RESOLUTION MEPC.81(43)
adopted on 1 July 1999
AMENDMENTS TO SECTION 9 OF THE STANDARD FORMAT FOR
THE COW MANUAL (RESOLUTION MEPC.3(XII))

ANNEX 12

**"SECTION 9: DETERMINATION OF THE SUITABILITY OF A CRUDE OIL FOR
USE IN CRUDE OIL WASHING"**

A Graph to determine The Cloud Point Temperature

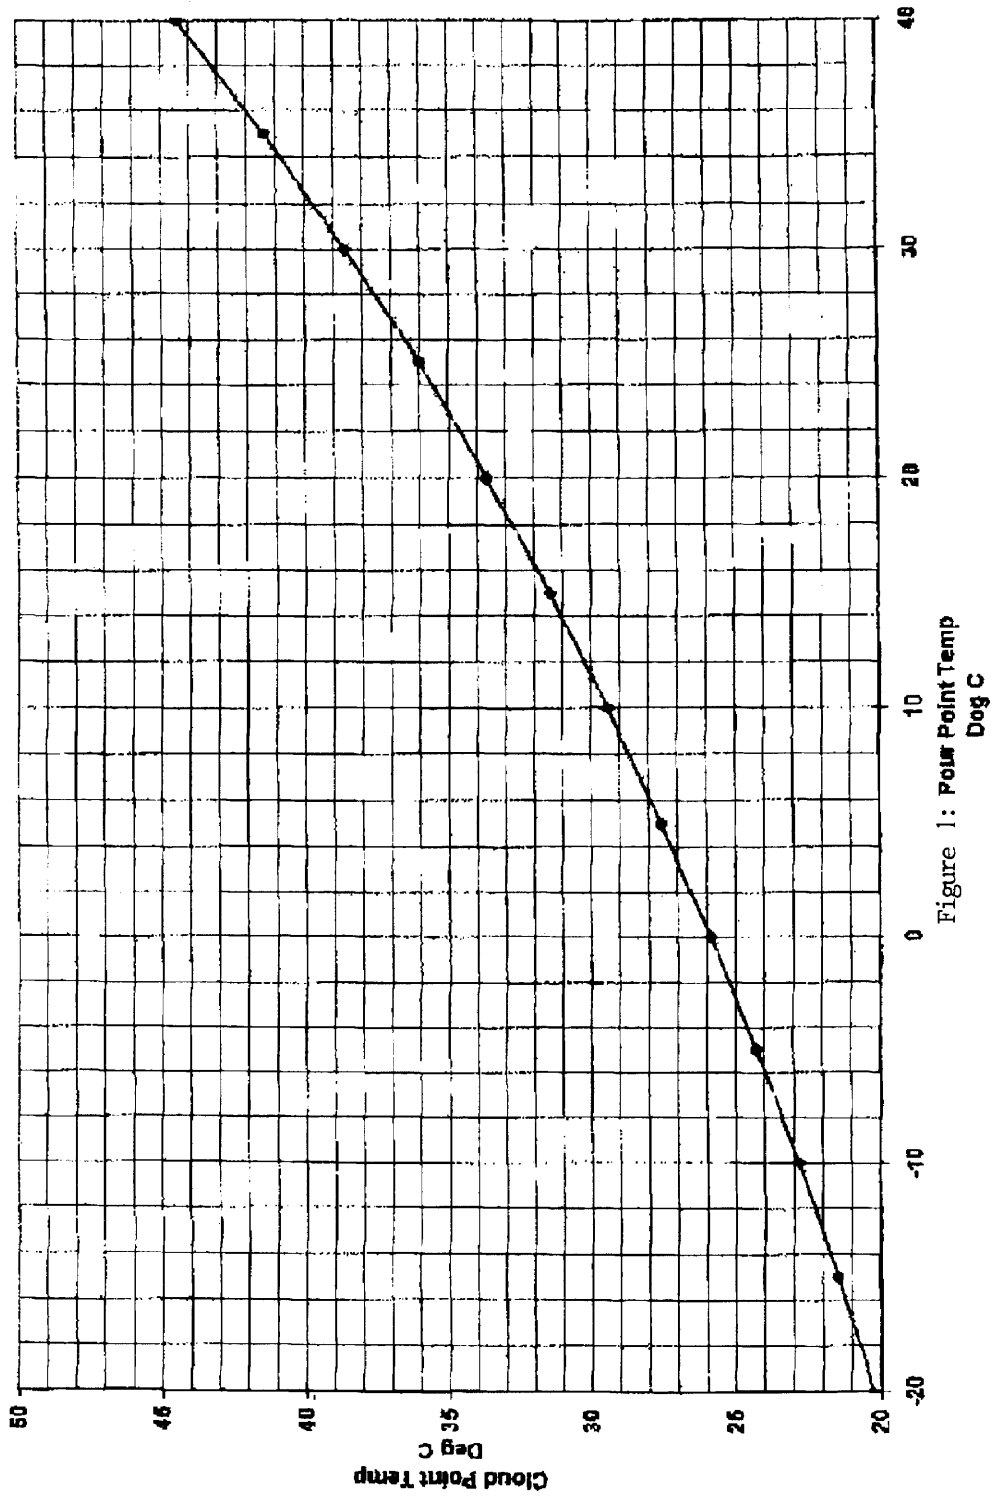
Consult the accompanying graph, (*Fig 1*) where if the Pour Point is known then the Cloud Point can be extracted.

Example Bondi Test Plot

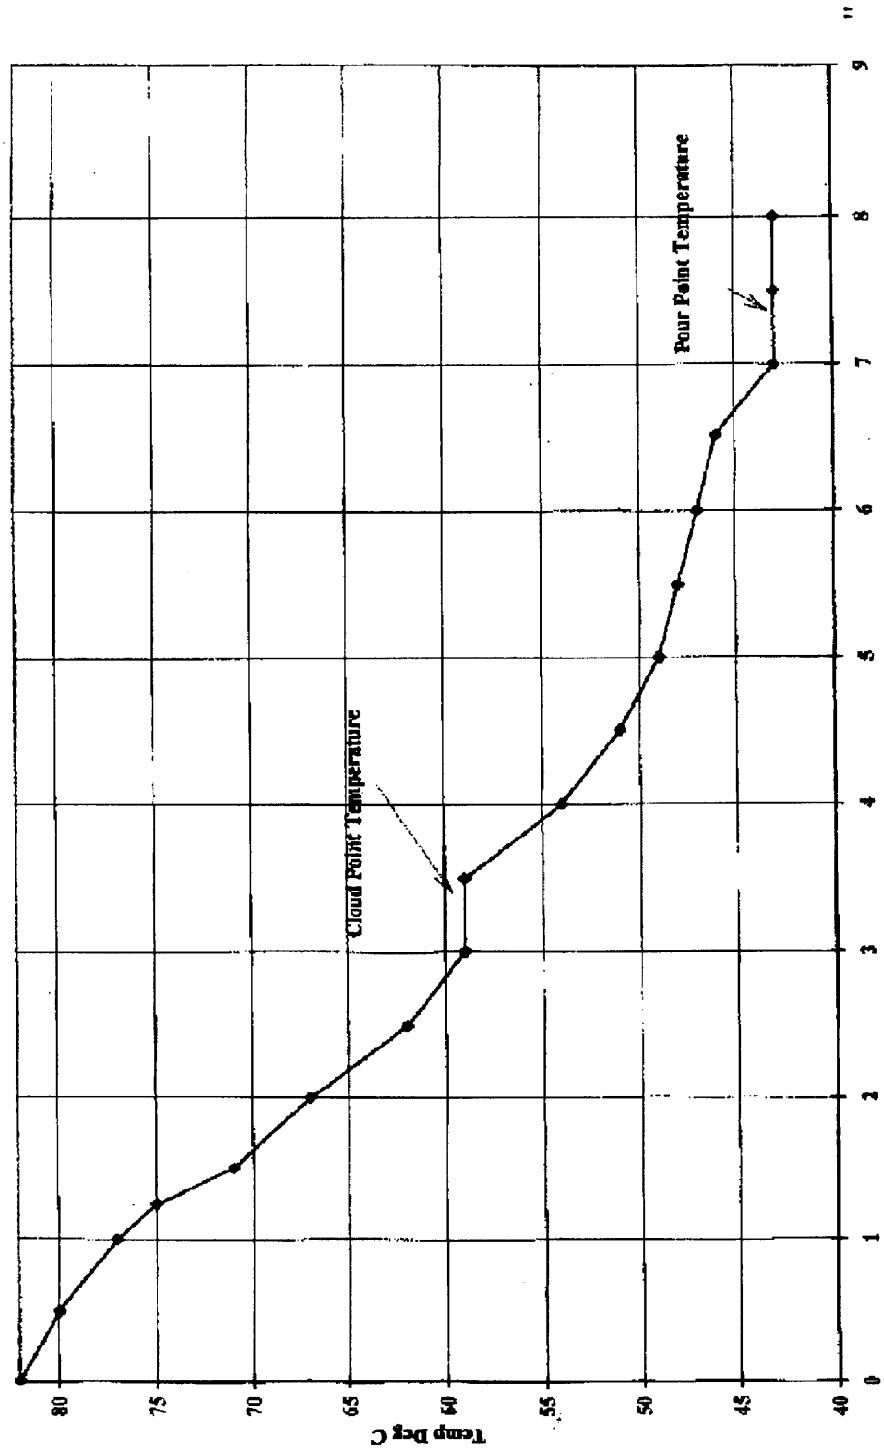
The Bondi Test Procedure (See Fig 2)

- (6) Graphically plot the sample temperature against time elapse from the start of the test. Determine the temperatures at which there was no loss of temperature with time elapse. The first such instance as detected will be the approximate Cloud Point temperature and the second instance, if testing time is extended to the required period, will be the approximate pour point temperature of the crude oil.
